Access Compliance Report Public Rights-of-Way (Curb Ramps)

Main Street: ANTONIO_PKWY		Cross Street: O_NEILL_DR		Location:	SE
ADA ID: RPRK211116125447	Ramp Type: Type 4 - Parallel	Initial Pass/Fail: Fail	Overall Compliance: No	Severity Score:	15
Codes/Mitigation Info/Possible Solution			Field Measurements/Component Compliance

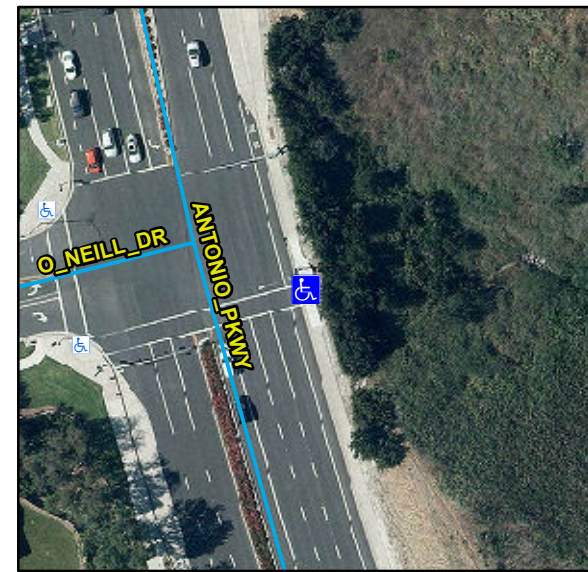
Compliance	Description	Data	Compliance	Description	Data
N/A	Ramp Length LT (in)	108	N/A	Ramp Length RT (in)	108
Yes	Ramp Width LT (in)	87	Yes	Ramp Width RT (in)	63
No	Ramp Run Slope LT (%)	8.8	Yes	Ramp Run Slope RT (%)	7.3
Yes	Ramp Cross Slope LT (%)	1.1	Yes	Ramp Cross Slope RT (%)	0.5
N/A	Landing Present	N/A	N/A	DWS Provided	N/A
N/A	Landing Length (in)	N/A	N/A	DWS Contrast	N/A
N/A	Landing Width (in)	N/A	N/A	DWS Length (in)	N/A
N/A	Landing Run Slope (%)	N/A	N/A	DWS Full Width	N/A
N/A	Landing Cross Slope (%)	N/A		DWS Offset Type	N/A
N/A	Landing Movement Obstructed?	N/A	N/A	DWS Offset Left (in)	N/A
	Landing Movement Type	N/A	N/A	DWS Offset Right (in)	N/A
N/A	Landing Shared	N/A			
N/A	Clear Space	N/A			
N/A	Clear Space To Crosswalk (in)	N/A			
N/A	Marked Crosswalk 1	Yes	N/A	Marked Crosswalk 2	N/A
	Crossing 1 Direction	W		Crossing 2 Direction	N/A
	Marked Crosswalk 1 Width (in)	144		Marked Crosswalk 2 Width (in)	N/A

Remove & Replace Entire Ramp.

R304.3.2, STD 1115
